Federal Recall Information

Recall for Trailer Antilock Brake System (ABS) Dash Indicator Light

Recall 106-A Indicator Light for Trailer Antilock Braking System (ABS)

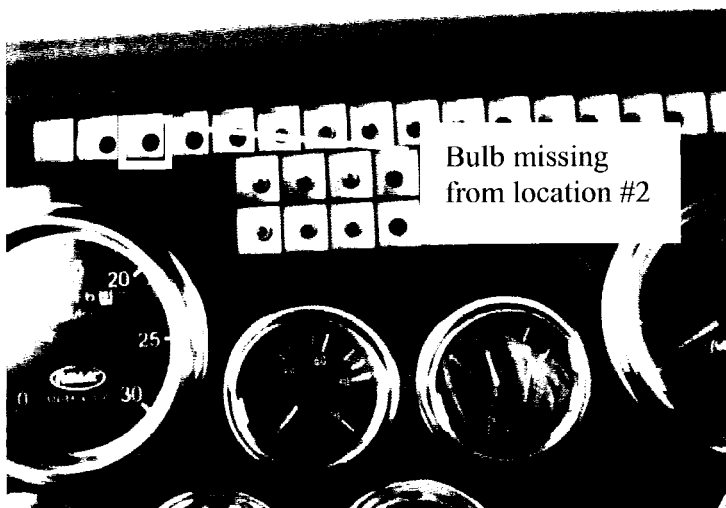
1. Remove the 4 screws holding the light bar to the dash panel

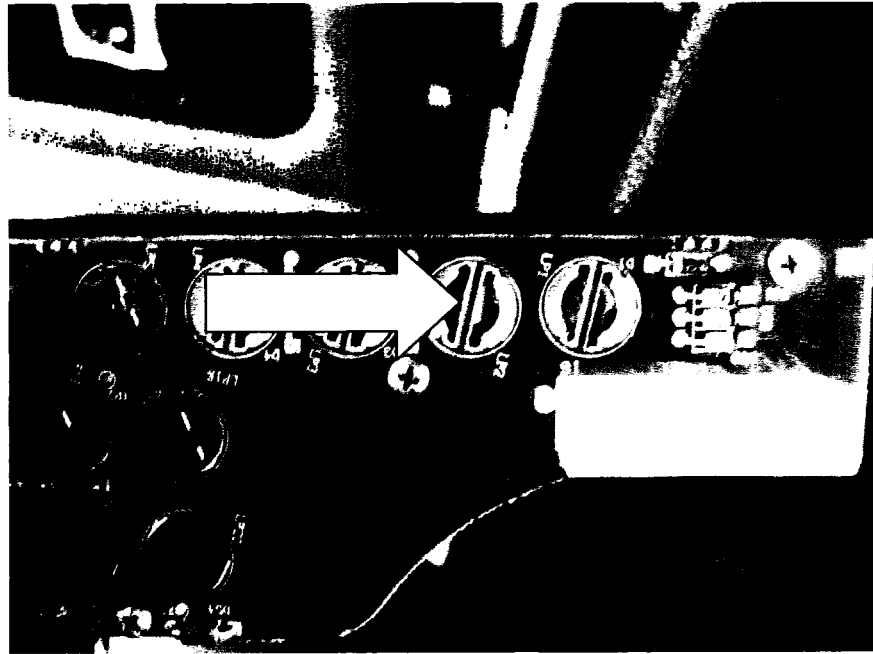
2. Remove Lens cover
3. Check for Trailer ABS Light in Location 2. If present, proceed directly to step 7.
4. If bulb is not present, remove light bar from dash.

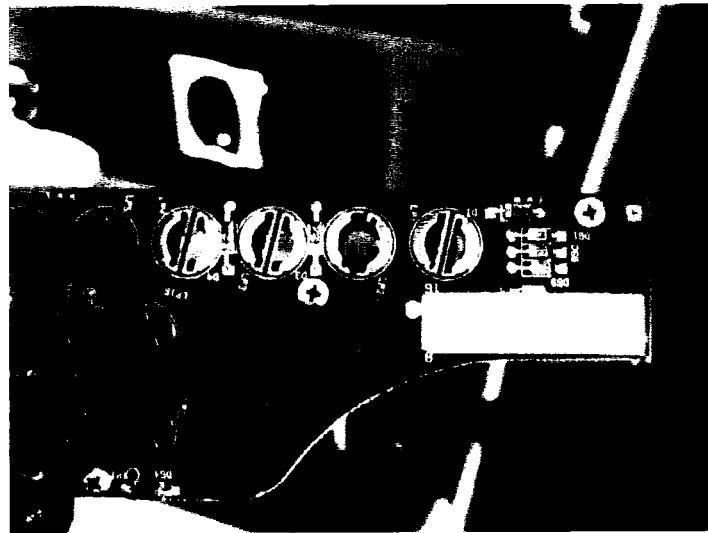
5. Remove plastic tab on the back side of the list bar with a flat head screwdriver on lamp # LP2

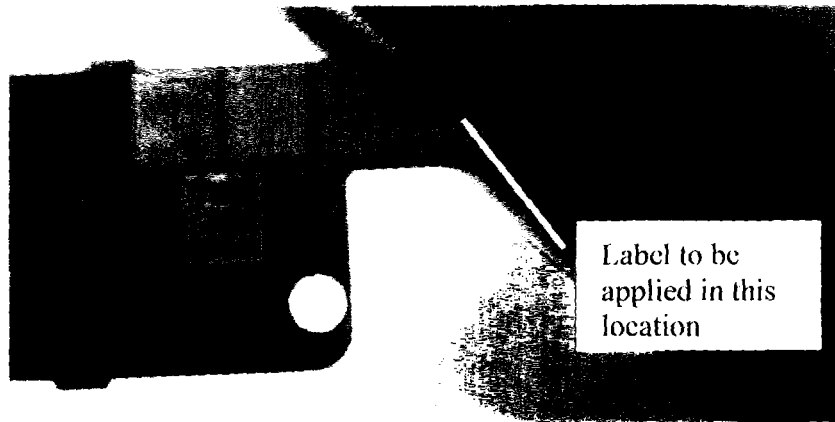
6. Insert bulb and socket
